From: Sent:	Tina Huerta Friday, July 11, 2014 4:09 PM	
To: Cc: Subject: Attachments:	Sonnamaker, William, EMNRD Donna Mull (donna.mull@state.nm.us)	HOBBS OCD AUG 07 2014

Bill Sonnamaker also looked at the MIT chart that the BLM approved for the Jackson Federal SWD #1, API # 30-025-28242 and stated it is the wrong chart. Yates needs to retest this well and use the correct chart.

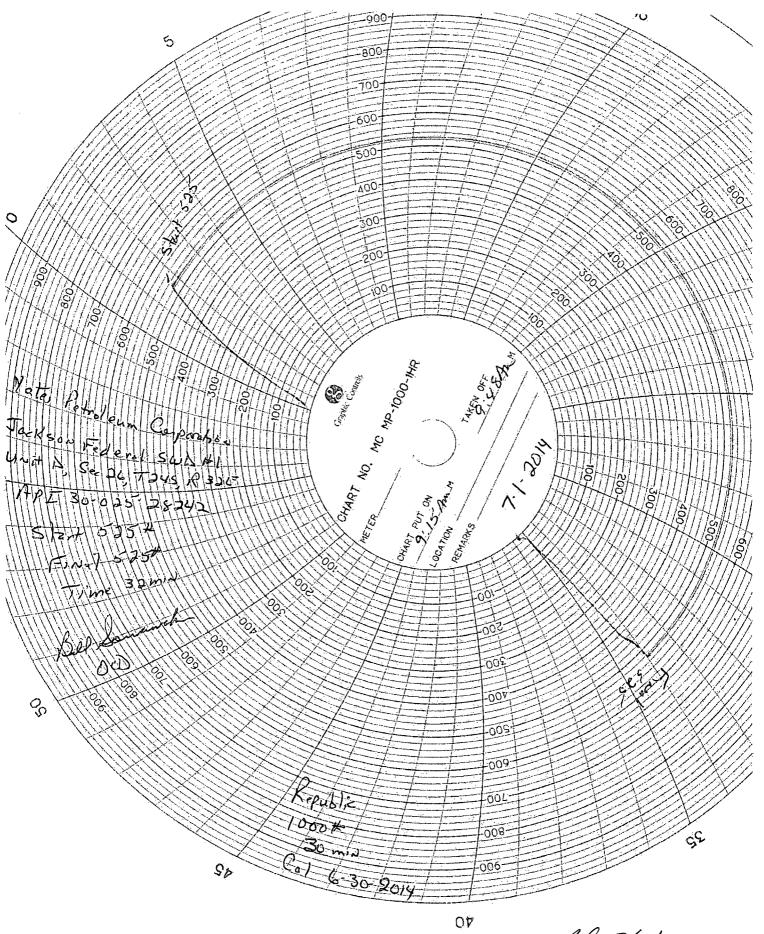
Chart & Spring should be 1000#, 1 hour clock, and a 35 min. test.

Here is the MIT chart that you requested a retest as noted below. Please let me know if there is anything else you need from me. Thank you.
